ASSESSMENT REPORT

Section 96(1A) Modification Oakdale South Industrial Estate (SSD 6917 MOD 4)

Figure 7: Proposed Precinct 1 and 2 Lot Layout

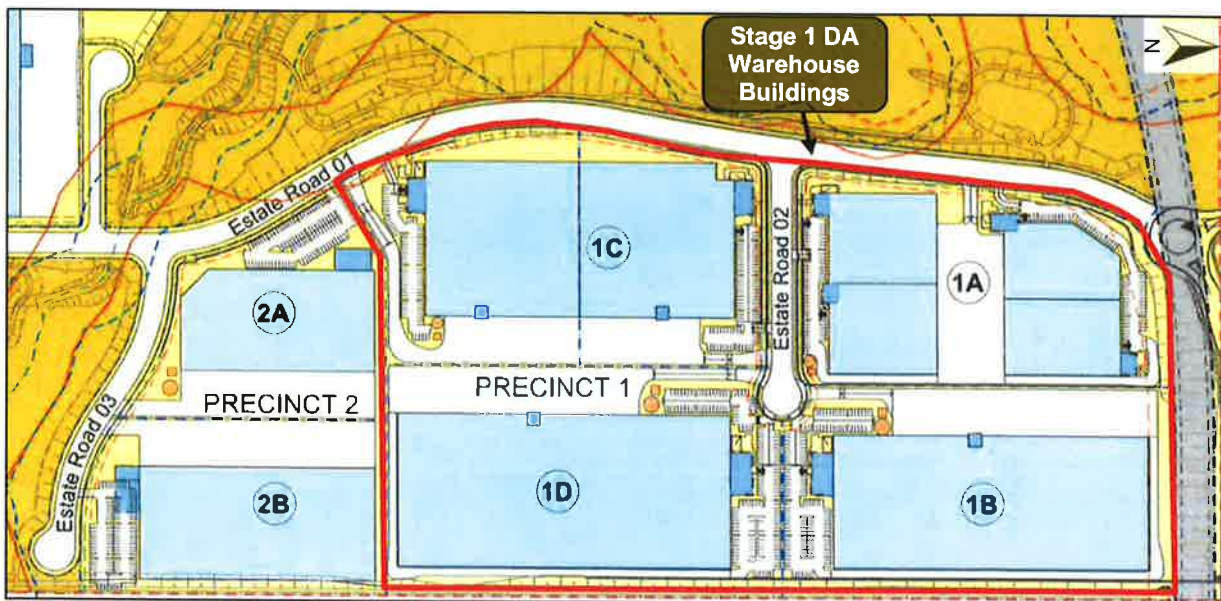
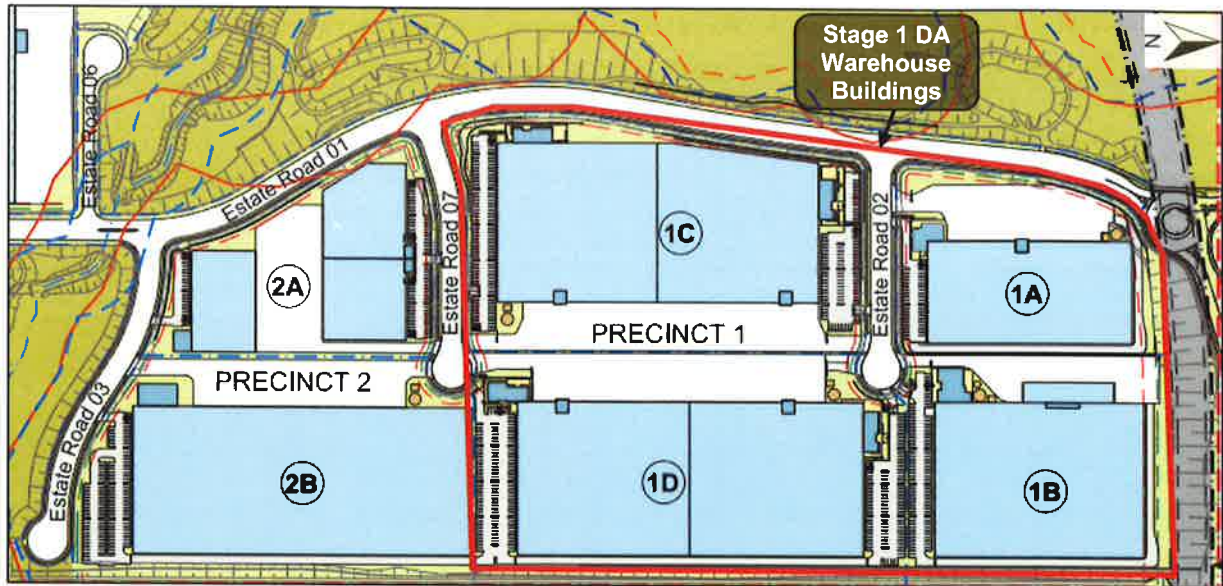
- amend the subdivision and lot layout for precincts 1 and 2
- amend the Estate road network
- increase the approved maximum GFA across the OSE
- reduce the developable area across the OSE
- add fire trails at precincts 1, 2, 3, 5 and 6.

Figure 8: Approved Lot 1A (left) and Proposed Lot 1A (right)

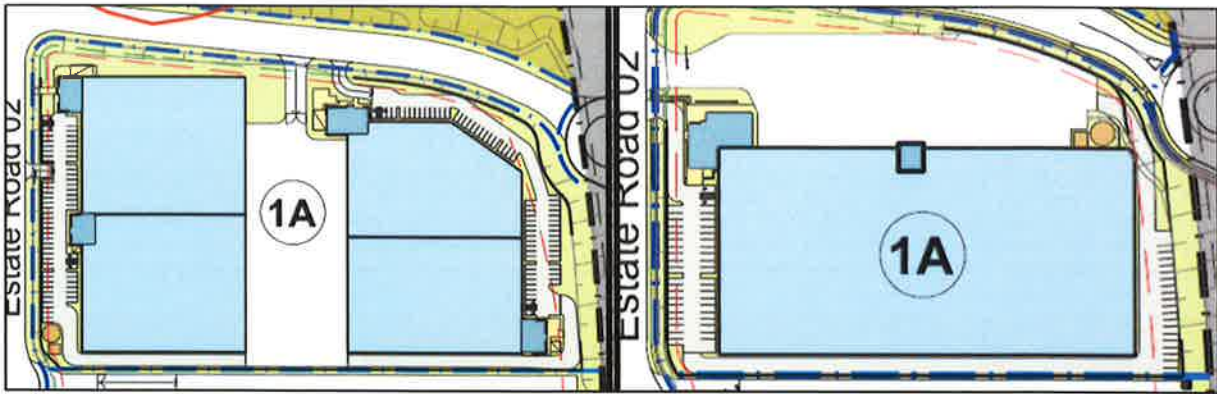
The proposed amendments to the layout of Lot 1A have the potential to increase the visual impact of the development to the external road network and Estate entrance as compared to the approved development. The proposed modifications to Lot 1A are depicted in **Figure 8** and include the consolidation of Warehouse 1A into one building (comprised of one tenancy) and the relocation of the loading dock and the tank and pump room to the western portion of the site. This reconfiguration of Lot 1A results in the loading dock, tank and pump room being visible from the Estate entrance and the road network.

In their submissions on the proposed amendments and the RTS, Council raised concerns regarding the visual impact of the loading dock to the road network and Estate entrance, and requested the Applicant to consider opportunities to improve the presentation.

While the relocation of the Lot 1A loading dock could result in an undesirable presentation to Estate Road 01 and the external road network, the Department considers the Applicant's proposed mitigation measures are satisfactory and would minimise the visual impacts. The mock-up sketch provided by the Applicant, shown at **Figure 10**, depicts physical constraints on Lot 1A imposed by the proposed amendments to Lot 1B; including the alignment of the Estate roads. The Department considers the warehouse orientation depicted in the mock-up sketch would have the potential to impact heavy vehicle safety and the functionality of the lot. The setback of the warehouse proposed also provides a visual break to the long walls along Estate Road 01 and increases solar access opportunities to the boundary planting at Lot 1A when compared to the alternative layout depicted in **Figure 10**.

The Department's assessment concludes that the impacts of the proposed amendments are acceptable given the scale and character of the development and the satisfactory mitigation measures which have been proposed. In its assessment, the Department has considered the concerns raised by Council and considers that the proposed screening measures would satisfactorily minimise the visual impact of the proposed amendments to Lot 1A. The proposed tank and pump room screening is of a design that is complementary to warehouse 1A and would satisfactorily screen the tank from public view points. Subject to satisfactory screen landscape planting in accordance with the approved plans, including the planting of 100 L trees prior to works commencing, the visual impact of the loading dock would be minimised. It is recommended that Condition E61, which requires the preparation of a Vegetation Management Plan, be amended to include the requirement for ongoing vegetation management, specifically related to the vegetation screening Lot 1A from Estate Road 01 to ensure it is adequately maintained to reach its maximum height to facilitate effective screening of the loading dock area.

Figure 10: Mock-up Sketch Depicting the Orientation of the Lot 1A Loading Dock away From Estate Road 01

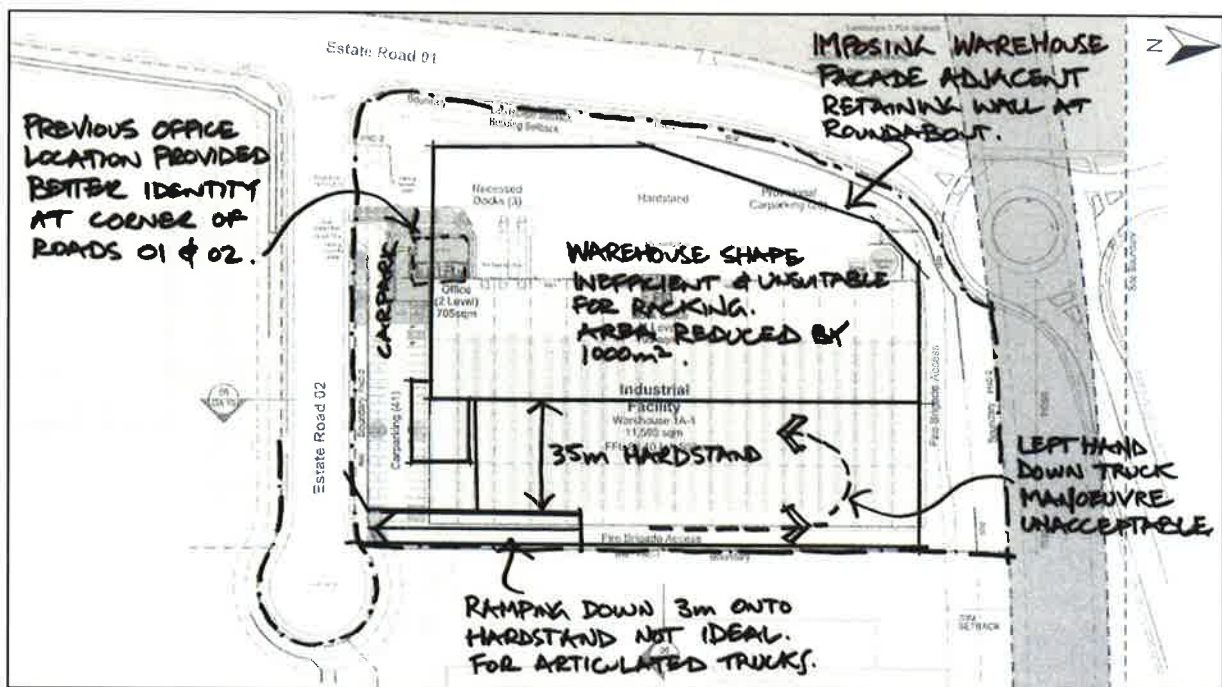
To support the proposed amendments to Lot 1A, the Applicant has submitted a written justification, mock-up sketch drawing of an alternative layout (**Figure 10**), plans for a tank screen and screen landscaping at Lot 1A. The Applicant's justification states that the amended site layout is in response to the operating needs of the tenant secured for Lot 1B. The Applicant considers the proposed lot configuration is optimal due to the restricted size of the lot, the constructed site levels and the shape of the land. The Applicant suggest reorienting the warehouse and loading dock would be operationally unfeasible because of the resultant shape of the warehouse, which would result in the loss of 1,000 m² of racking space and the requirement for a ramp up to the loading dock, which would take up a large portion of the loading dock area and cause difficult heavy vehicle maneuvers. The mock-up sketch shown at **Figure 10** was submitted to illustrate this.

Figure 11: Section of Proposed Landscaping Between Lot 1A and Estate Road 01

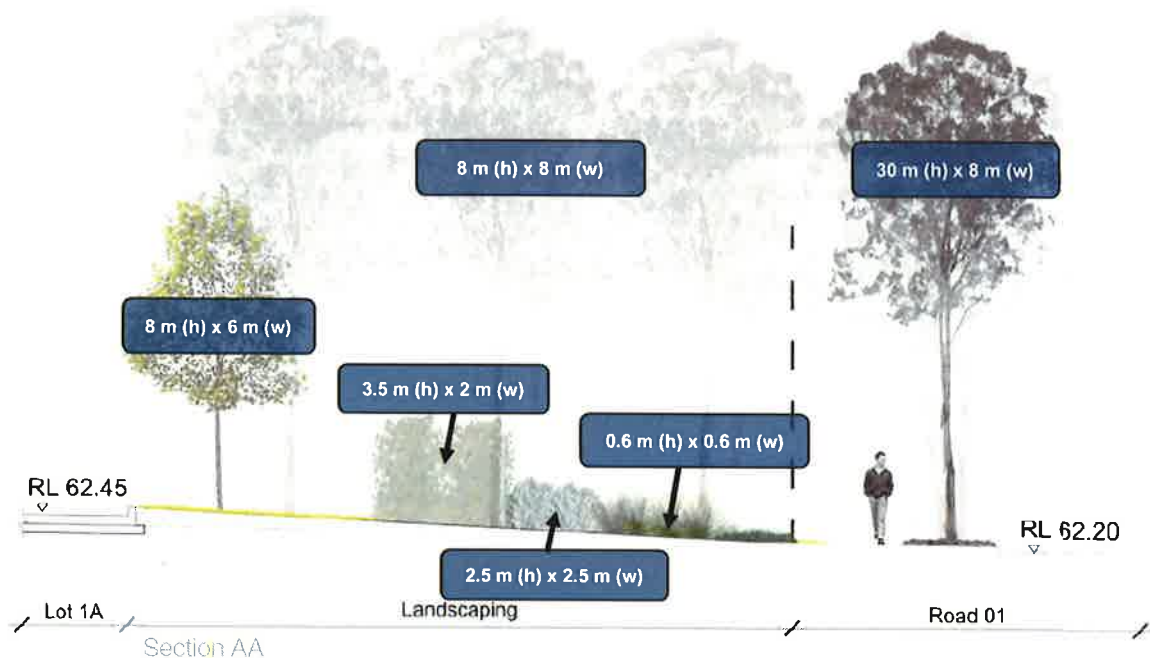
Furthermore, the Applicant has stated that by setting the warehouse back, the visual bulk and scale of the warehouse would be reduced and the additional landscaping would reduce the visual impacts to the Estate entrance and road network. To support this, the Applicant has submitted landscaping plans (see **Figure 11**) proposing several vegetative layers comprised of various grasses, shrubs and trees ranging between 0.6 m (h) x 0.6 m (w) and 30 m (h) x 8 m (w) at their maximum mature size. The Applicant has proposed for on-lot trees to be planted at a pot size of 100 litres (L) and all shrubs at 300 millimetres (mm) to facilitate the immediate use of the vegetation for the purposes of screening. The Applicant has noted that 300 mm is the largest shrub size available. The installation heights of 100 L trees would be between 2.5 m and 3m and shrubs would have an installation height of approximately 0.65 m. The Applicant has also submitted plans for a tank and pump room screen (see **Figure 9**).

The Applicant has proposed additional landscape plantings adjacent to the western boundary of Lot 1A in response to the concerns raised by both the Department and Council. The proposed screen planting includes a variety of plants of different heights, spread and foliage densities. As well as screening the loading dock area, this landscaping also has the potential to create visual appeal in an industrial area. Subject to the Applicant providing adequately mature plants at installation and adequately maintaining the vegetation, screening would be provided for the life of the development and the Department is satisfied that adequate screening would be provided from "installation" with the planting of semi-mature trees. However, to ensure trees and shrubs are established early, the Department has recommended a

condition of consent that plantings are established prior to the commencement of construction of the warehouse.

Figure 12: Proposed Car Parking at Lot 1A (left) and Amended Car Parking (right)

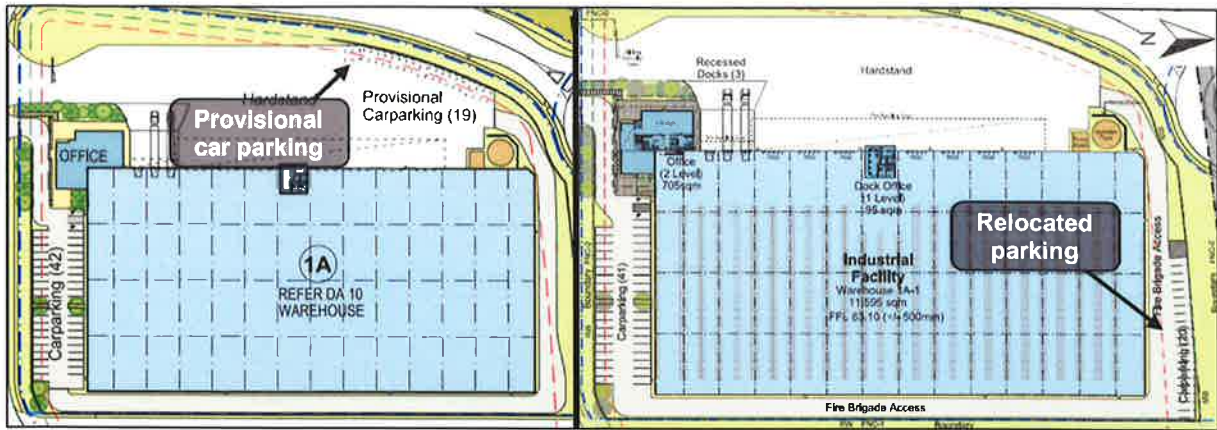
The MOD 4 plans originally submitted demonstrated compliance across Lots 1B, 1C and 1D however the proposed arrangement for Lot 1A showed 19 "provisional" car parking spaces, located adjacent to the north-western lot boundary and within the loading dock area. The Department raised concerns regarding pedestrian and vehicle safety, the combined heavy and light vehicle access point and the implication of "provisional" meaning temporary. Without these car parking spaces, Lot 1A would not satisfy the minimum number of car parking spaces required by Condition C5. Further to this, Condition C6 requires heavy and light vehicle access to be separate.

Amended plans submitted by the Applicant removed the word “provisional” and relocated these car parking spaces to the northern boundary of Lot 1A as shown in **Figure 12**. Subsequently, this made the car parking spaces fixed and separated the heavy and light vehicle entry points to Lot 1A. The Applicant also submitted a justification for the location of these car parking spaces stating that no more than 30 staff would be required for the day-to-day operation of activities at Warehouse 1A, car parking for which could be satisfactorily catered for in the main car park at the southern end of Lot 1A, thereby leaving the parking area adjacent to the northern boundary for overflow parking only.

The Department’s assessment concludes the proposed amendments to precinct 1 are consistent with the approved parking rates for the OSE and that separation of heavy and light vehicles is adequate to facilitate the safe ingress and egress of vehicles. It is recommended that Condition E5 of the development consent be amended to reflect the updated car parking requirements. It is also recommended a condition be added to the consent requiring the installation of safety devices within the car parking area to manage vehicle and pedestrian interactions within Lot 1A (see **Figure 13**). Measures should include, but not be limited to clear delineation of vehicle and pedestrian paths, safety railing adjacent to the proposed pedestrian path, adequate lighting and safety mirrors at corners and points of low visibility.
